Access Compliance Report Public Rights-of-Way (Curb Ramps)

Intersection ID: 17196Main Street:IDLEWILD_RDCross Street:CONFERENCE_DRLocation:SWADA ID: 56490532FBD4Ramp Type:PerpInitial Pass/Fail:FailOverall Compliance:NoSeverity Score:22.5

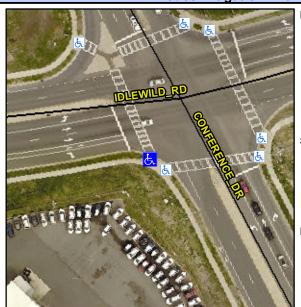
1 CCCIBIC CCIALICIT	
Possible Solutions:	9
Remove & Replace Entire Ramp.	N
	N
	N
	N
	N
	N
Surveyor Notes:	N
N/A	N
	N
	N
	N
PROW/ADA:	N
R304.5.1, R304.2.2, R304.5.3	N
	N
	N
	N
	ľ

Field Measurements/Component Compliance								
Compl	iance Description	Data	Comp	liance	Description	Data		
N/A	Ramp Length (in)	67.0	No	Ramp	Slope (%)	9.4		
No	Ramp Width (in)	47.0	No	Ramp	XSlope (%)	4.8		
N/A	Flare Type LT	N/A	N/A	Flare	Type RT	N/A		
N/A	Flare Slope LT (%)	N/A	N/A	Flare	Slope RT (%)	N/A		
N/A	Flare Traversable LT?	N/A	N/A	Flare	Traversable RT?	N/A		
N/A	Landing Length (in)	N/A	N/A	DWS	Provided?	N/A		
N/A	Landing Width (in)	N/A	N/A	DWS	Contrast?	N/A		
N/A	Landing Slope (%)	N/A	N/A	DWS	Length (in)	N/A		
N/A	Landing X Slope (%)	N/A	N/A	DWS	Full Width?	N/A		
N/A	Landing Curb? (Y/N)	N/A	N/A	DWS	Offset (in)	N/A		
N/A	Shared Landing?	N/A						
N/A	Gutter Ponding?	N/A	N/A	Gutte	r Slope (%)	N/A		
N/A	Gutter Lip Ht (in)	N/A	N/A	Gutte	r X Slope (%)	N/A		
N/A	Painted X Walk1?	Yes	N/A	Paint	ed X Walk2?	N/A		
	X Walk 1 Direction	To NW		X Wa	lk 2 Direction	N/A		
N/A	X Walk 1 Width (in)	104.0	N/A	X Wa	lk 2 Width (in)	N/A
